SERVICE BULLETIN

TITLE: ENGINE CONTROLS - THROTTLE WARNING/GEAR RETRACTION PREVENTION CAM INSPECTION/INSTALLATION

Issued: February, 2006
Revised: March, 2006

SB 76-3763, Rev. 1

Figure 1

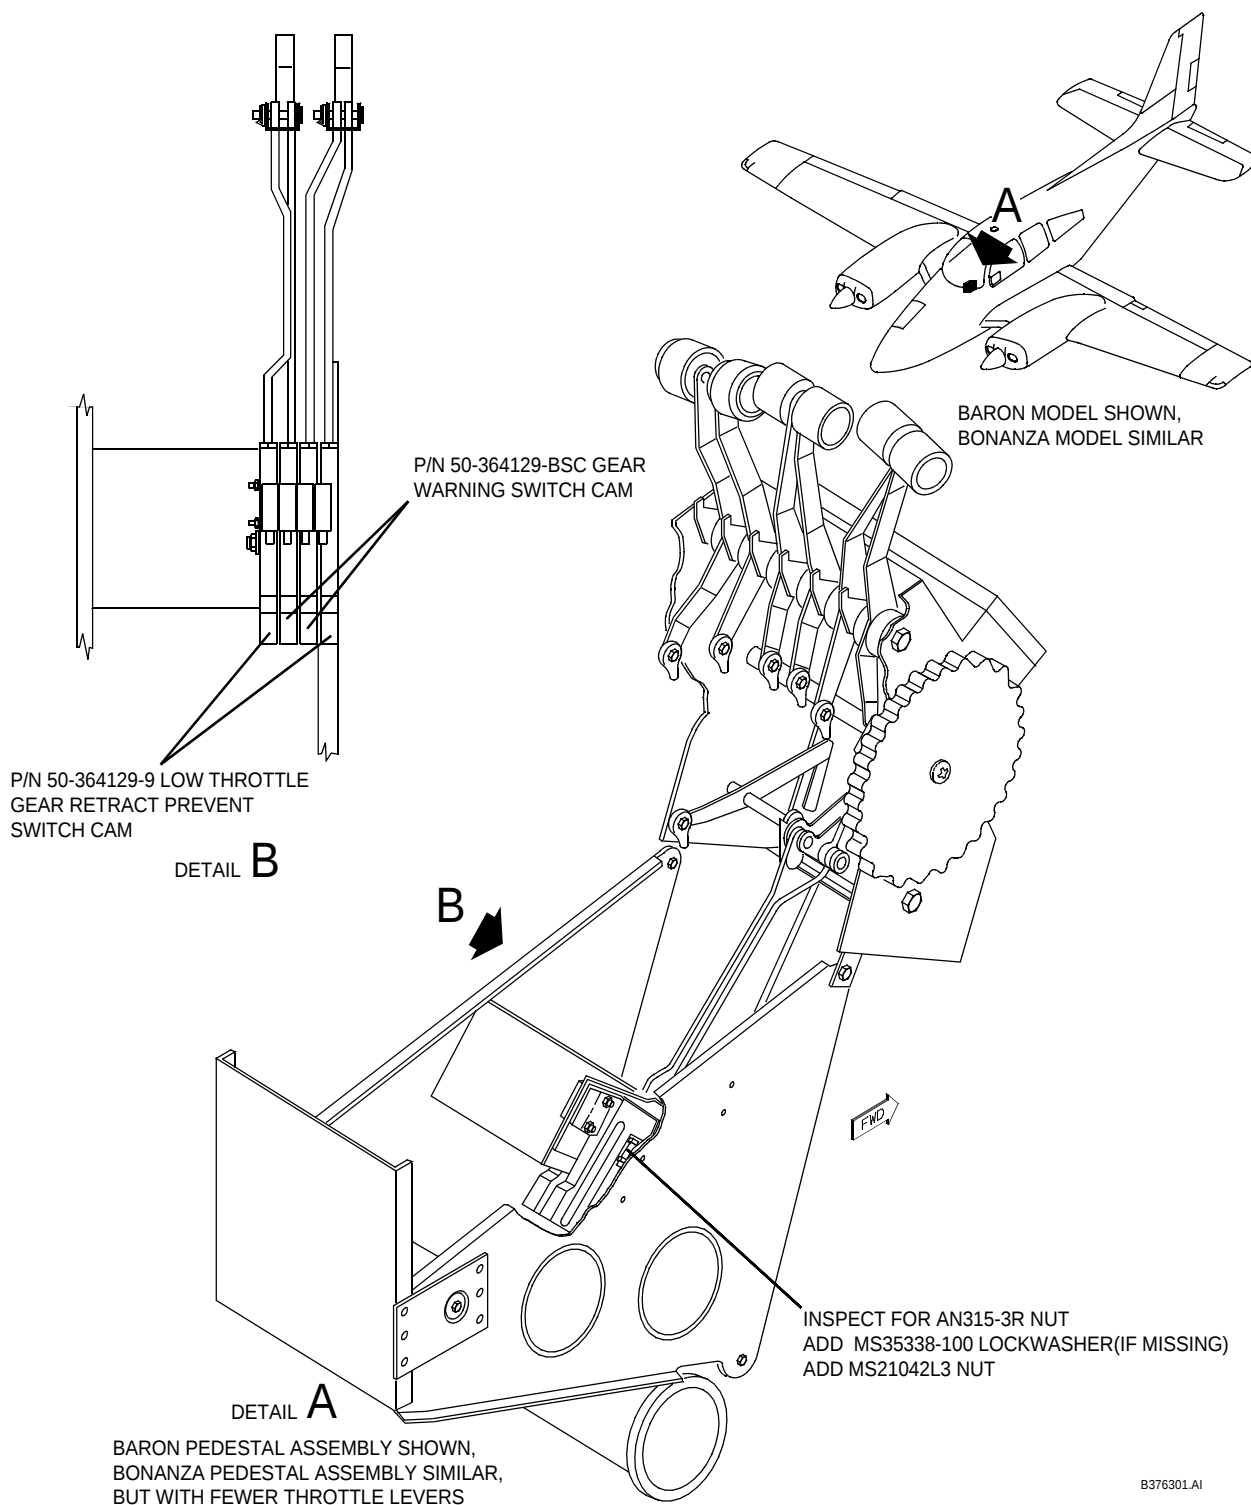
- (1) Remove all power from the airplane and disconnect the battery. Display warning notices prohibiting reconnection of airplane electrical power.
- (2) Gain access to the airplane flight compartment and locate the pedestal assembly. Refer to Figure 1.
- (3) Remove attaching hardware and the pedestal cover. Retain attaching hardware. Locate the throttle warning switch/gear retract prevent switch cams in the pedestal assembly.
- (4) Inspect the cam actuator rods for presence of a MS35338-100 lockwasher and AN315-3R nut on the actuator rod. Refer to Figure 2.
- (5) Verify that the AN315-3R nut is torqued to 18-20 inch-pounds, not to exceed 25 inch-pounds torque. If MS35338-100 lockwasher is present and the AN-315-3R nut is properly torqued, proceed to steps (7) through (13),
- (6) Inspect for the following conditions and correct any deficient conditions:

- (a) Lockwasher missing - If missing, remove the AN315-3R nut, install an MS35338-100 lockwasher on the throttle cam actuator rod, and reinstall the AN315-3R nut.
- (b) AN315-3R nut backed off of the actuator rod - Secure nut against lockwasher.
- (c) Proper torque - Using appropriate size torque wrench, apply 18-20 inch-pounds torque, not to exceed 25 inch-pounds torque, to the nut.
- (d) Repeat steps (6) (a) through (6) (c) for each actuator rod.
- (7) Install a new MS21042L3 or P/N 130909N29(back-up) lock nut on the end of each actuator rod. Tighten until a minimum of three threads of the throttle cam actuator rod are exposed.

If locknut cannot be installed with minimum thread requirement, apply Loctite 243 thread locking compound to AN315-3R nut and omit locknut.

Inspection of Throttle Warning Switch/Gear Retract Prevent Switch Cams for Proper Hardware and Torque
Figure 2

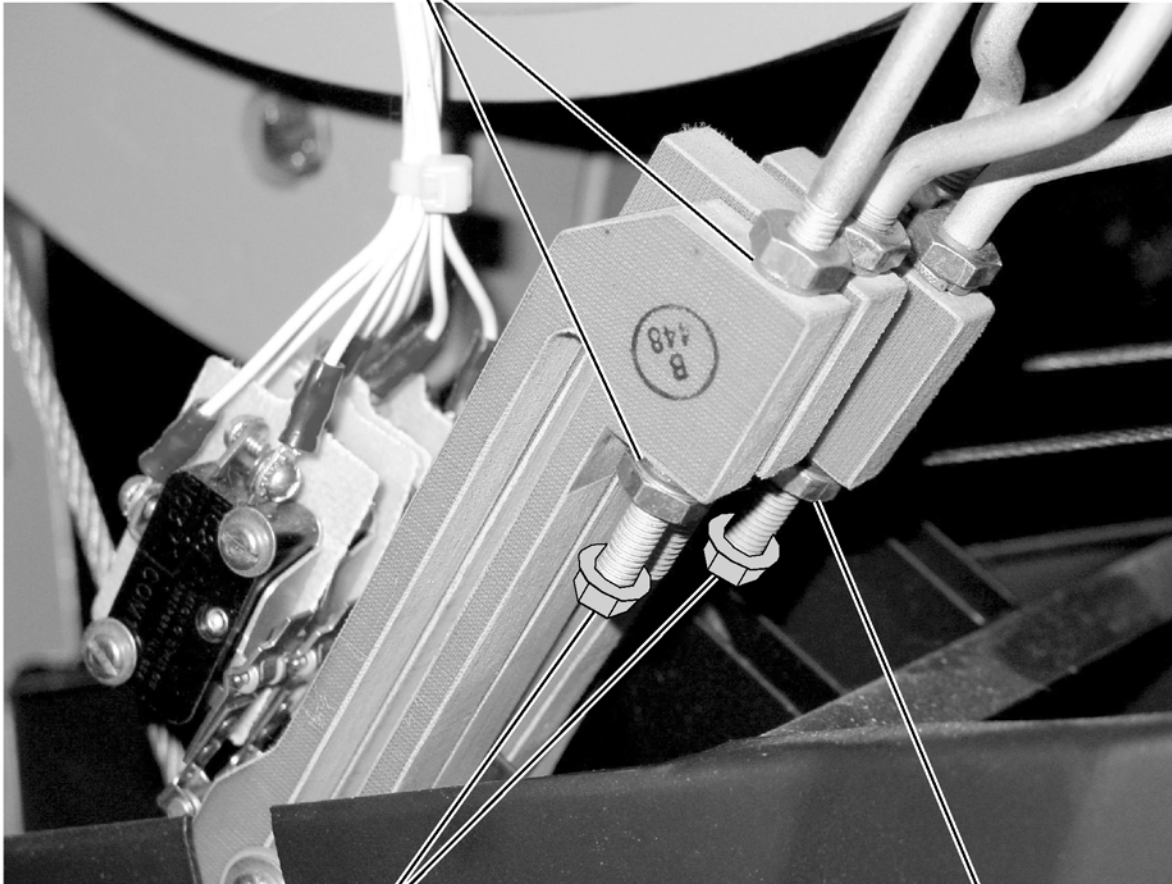
VERIFY MS35338-100 LOCKWASHER IS
INSTALLED ON EACH CAM ACTUATOR ROD.

INSTALL NEW MS21042L3 NUT (TYPICAL 4 PLACES)
ON EACH THROTTLE WARNING SWITCH/GEAR
PREVENT SWITCH CAM ACTUATOR ROD.
TIGHTEN UNTIL A MINIMUM OF THREE THREADS
ARE EXPOSED.

VERIFY AN315-3R NUT HAS NOT BACKED
OFF AND PROPER TORQUE IS APPLIED IN
ACCORDANCE WITH ACCOMPLISHMENT
INSTRUCTIONS.

IF LOCKNUT CANNOT BE INSTALLED WITH MINIMUM
THREAD REQUIREMENT, APPLY LOCTITE 243 THREAD
LOCKING COMPOUND TO AN315-3R NUT AND OMIT LOCKNUT.
